Applic. No. 10/673,706
Amdt. dated March 14, 2005
Reply to Office action of December 14, 2004

Drawing Amendments

FIG 2

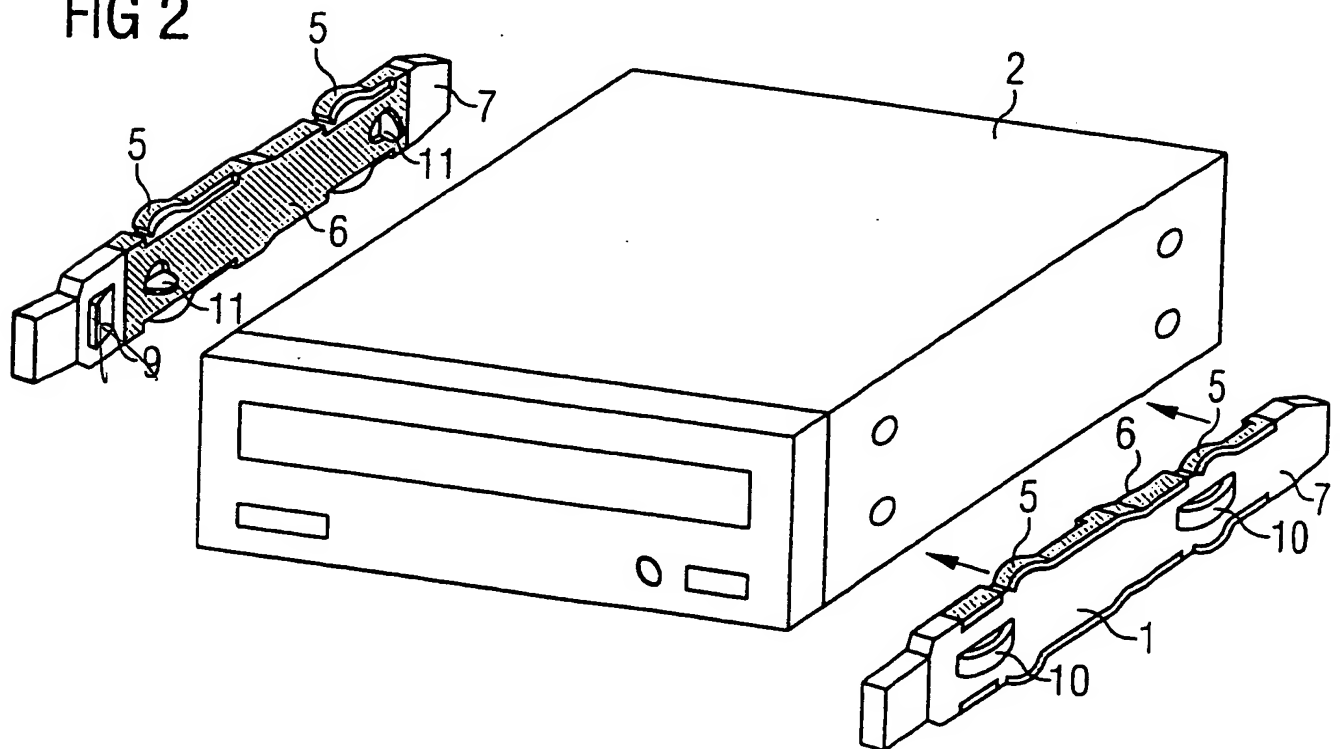
The attached sheet of drawings includes changes to Figs. 2, 3, and 4. These sheets which include Figs. 1-5, replace the original sheets including Figs. 1-5. In Fig. 2, 3, and 4, the latching element "9" is now shown on the opposite side of the plastic element "7".

The Examiner stated that the latches 9 seem to be shown on the incorrect side. As noted above, Figs. 2, 3, and 4 have been changed so as to show the latches "9" on the correct side of the plastic element. Therefore, the objection to the drawings by the Examiner is believed to have been overcome.

Please approve the drawing changes that are marked in red on the accompanying "Annotated Sheet Showing Changes" of Figs. 2, 3, and 4. Formal "Replacement Sheets" of amended Fig. 2, 3, and 4 are also enclosed.

FIG 3

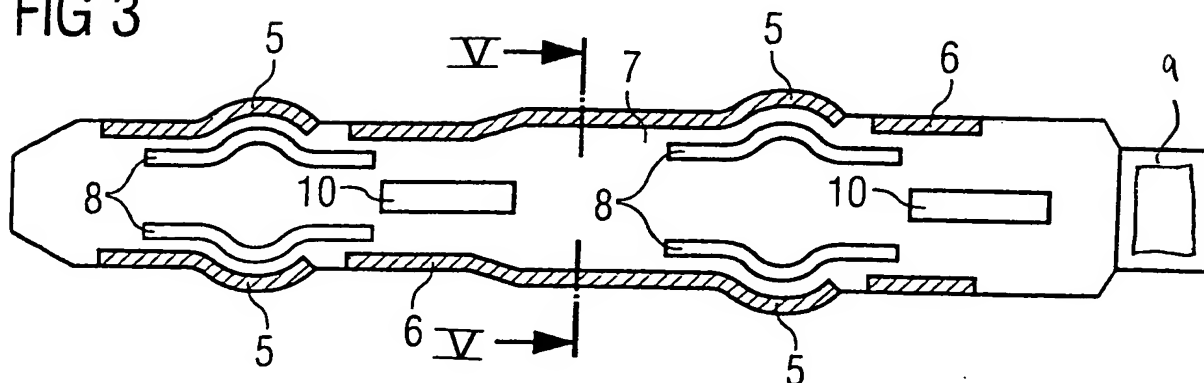
The Examiner alleges that the underlays 8 are confusingly shown and that it is unclear how these would aid resiliency of parts 5. It is respectfully noted that the instant application does not disclose that the underlays 8 aid the resiliency of the retaining elements 5. The Examiner is directed to Fig. 3 and page 8, lines 21-25 of the specification of the instant application, where it is disclosed that the plastic underlays 8 prevent the retaining elements 5 from being over bent under mechanical loading. Fig. 3 clearly shows that the underlays 8 are disposed below

the retaining elements 5 and thus serve to limit the amount of deflection possible for the retaining elements 5. Therefore, the drawings have not been amended with respect to the underlays 8.

The Examiner stated that claims 2 and 8 are based on a non-enabling disclosure for the reasons set forth above. Claim 2 merely states that underlay elements are disposed underneath the resilient retaining elements. This is not complex and it is clearly shown in Fig. 3. Accordingly, the disclosure is believed to be fully enabling. Therefore, claim 2 has not been amended to overcome the rejection.
